OPTIREG™ PMIC TLF35584QVHSx

Functional Safety Power Management IC

Errata Sheet

Reference: Datasheet Rev 2.0 (TLF35584QVHSx)

Figure 1 Interrupted SYN output for activated spread spectrum (FRE pin to GND - LF)

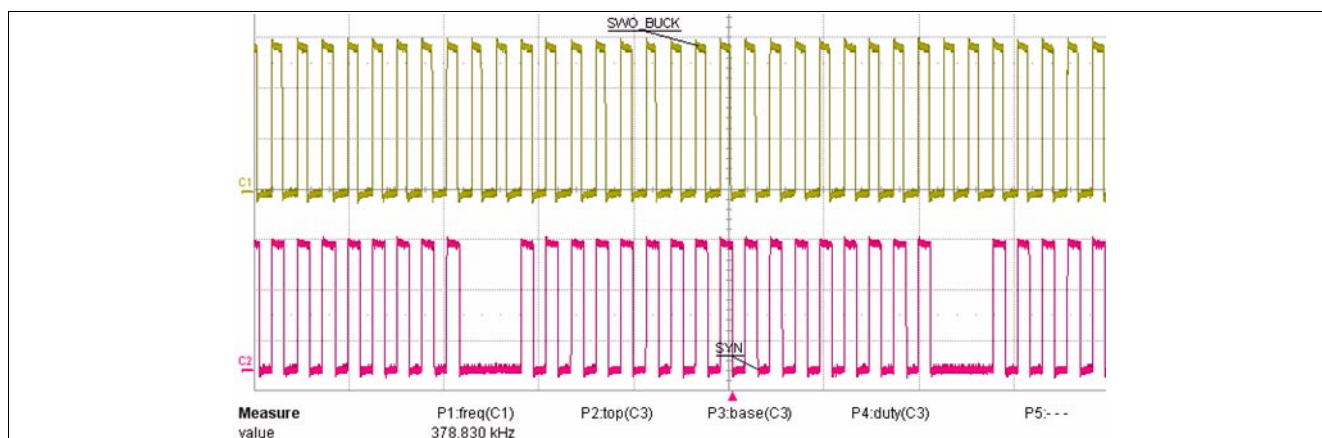
Number	Function	Description
1	Synchronization output signal with active spread spectrum	<ul style="list-style-type: none"> There is a weakness of the D11-step silicon for the synchronization output signal for the optional core voltage regulator during activated spread spectrum. In case the synchronization output SYN is being used and connected to an external switched mode power supply, it should be taken into consideration that the SYN-output signal might be interrupted unintentionally in a random way for activated spread spectrum. In Figure 1 and Figure 2 it is shown how the signal of SYN might look like. The figures have been generated using the synchronization without phase shift (DEVCFG2.ESYNPHA = 0). For this configuration the SYN output signal will stuck to low signal temporarily. For configuration with 180° phase shift (DEVCFG2.ESYNPHA = 1) the stuck signal would be high level.

Figure 3 **Reset Output (ROT) weakness - Example: Short to GND detection of QUC**

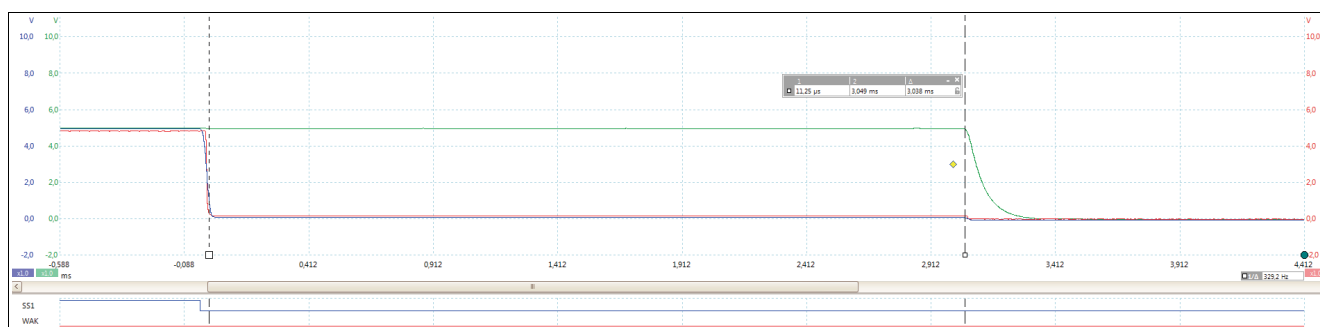
Number	Function	Description
1	Reset output ROT behavior in Move-to-FAILSAFE conditions	<ul style="list-style-type: none"> There is a weakness of the D11-step silicon related to the reset output pin ROT, in case the TLF35584 moves to FAILSAFE state. In a safety context the reset function and the reset output ROT are considered to be QM, accordingly safety is not affected. The output driver of the open drain transistor in the reset output ROT is disabled together with the microcontroller supply LDO (QUC). According to the fact that the QUC is disabled/switched off in case of a Move-to-FAILSAFE event, the reset output is not longer pulled to low signal and is pulled up to QUC. As the QUC is disabled and the output cap is discharged by the load and an internal active pull-down of $\sim 80\ \Omega$, this is reflected in a transient behavior which is shown in the figures below. The observation and relevance strongly depends on the failure case and its boundary conditions. These conditions are elaborated in the following list. <ul style="list-style-type: none"> QUC shorted to GND: The voltage monitoring detects the UV and pulls down ROT. SS1/2 are going low and application is in safe state. QUC is shorted to GND and has 0V accordingly, but provides current (still enabled). After typ. 3ms TLF35584 moves to FAILSAFE state and disables the LDO and resets the output driver of ROT. Due to the short to GND ROT stays low as it is pulled to QUC. (no problem) Please refer to Figure 3. QUC overloaded by current. The voltage monitoring detects the UV due to the decreased output voltage by current limitation or dropout voltage (only without boost) and pulls down ROT. SS1/2 are going low and application is in safe state. Due to the assertion of ROT the microcontroller is switched off and decreases its current consumption dramatically. The output voltage of QUC might recover into valid voltage range and the TLF35584 restarts in INIT state. (no problem) Continuous UV or short to GND on QST or VCI: The voltage monitoring detects the UV on the respective rail and pulls down ROT. SS1/2 are going low and application is in safe state. QUC continues to regulate to its nominal output voltage. After typ. 3ms TLF35584 moves to FAILSAFE state and disables all LDO and resets the output driver of ROT. The reset output might be pulled up to the discharging QUC (by the attached load and an active pull-down of $\sim 80\ \Omega$). This might result into a temporary high level at ROT during the shutdown transition. A undervoltage monitoring of the microcontroller could prevent undesired start of the microcontroller operation. Please refer to Figure 4. Continued on the next page.

Number	Function	Description
1 (cont'd)	Reset output ROT behavior in Move-to-FAILSAFE conditions (cont'd)	<ul style="list-style-type: none"> Continued: <ul style="list-style-type: none"> QUC shorted to an higher voltage rail: The voltage monitoring detects the OV on the QUC rail and SS1/2 are going low and application is in safe state. TLF35584 will move to FAILSAFE which is disabling QUC as well as all other regulators and activates the active pull-down of $\sim 80\ \Omega$ on QUC output, trying to discharge the rail. The FAILSAFE state disables also the output driver of ROT. The reset output might be pulled up to QUC. This might result into a high level at ROT during presence of the external overvoltage. Still the application will be safely shut down during in this case by SS1/2. Please refer to Figure 5.
2	Reset output ROT behavior for Move-to-STANDBY transitions	<ul style="list-style-type: none"> There is a weakness of the D11-step silicon related to the reset output pin ROT, in case the TLF35584 moves to STANDBY state. In a safety context the reset function and the reset output ROT is considered to be QM, accordingly safety is not affected. The output driver of the open drain transistor in the reset output ROT is disabled shortly after the microcontroller supply LDO (QUC). According to the fact that the QUC is disabled/switched off at the point in time when the device enters into STANDBY state (transition delay time expired or in case of QUC current monitoring usage after a decrease below the current threshold), the reset output shortly pulled to low, but pulled up to the output voltage of QUC right after. Nevertheless the output of QUC is actively discharged by the load and an internal active pull-down of $\sim 80\ \Omega$, this is reflected in a transient behavior which is shown in Figure 6 below.

Figure 7 Interrupted state transition NORMAL-STANDBY (MPS pin set low)

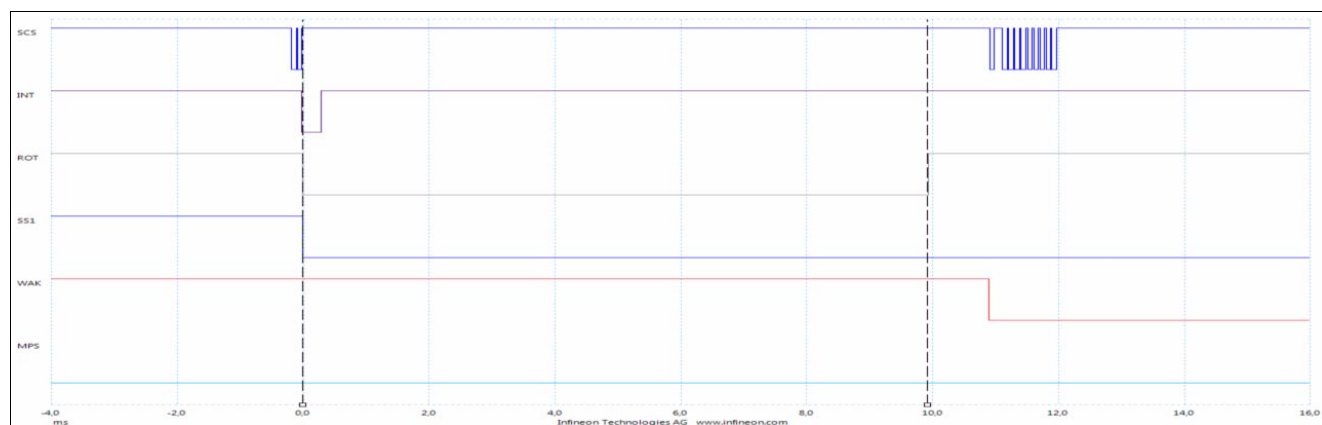
9	Microcontroller programming support (MPS) influence to state transition NORMAL/WAKE to STANDBY	<ul style="list-style-type: none"> The chapter 11.7 in the Datasheet Rev 2.0 (TLF35584QVHSx) describes influences to the overall device behavior of the TLF35584. Beside the described differences there is a unintended influences to the device behavior in case of microcontroller programming support being active (MPS-Pin high) for the movement NORMAL/WAKE to STANDBY. <ul style="list-style-type: none"> For the particular case of an interrupted state transition from NORMAL/WAKE to STANDBY due to a wake-up event by WAK (level) or ENA(edge) during the transition, the TLF35584 is not triggering ROT to low when moving to INIT state. Accordingly the behavior with and without MPS being activated can be compared by Figure 7 and Figure 8. Nevertheless the interrupted transition is triggering in both cases an interrupt event and reports the interrupted state transition by the interrupt register IF.SYS and the subsequent diagnostic register SYSSF.TRFAIL.
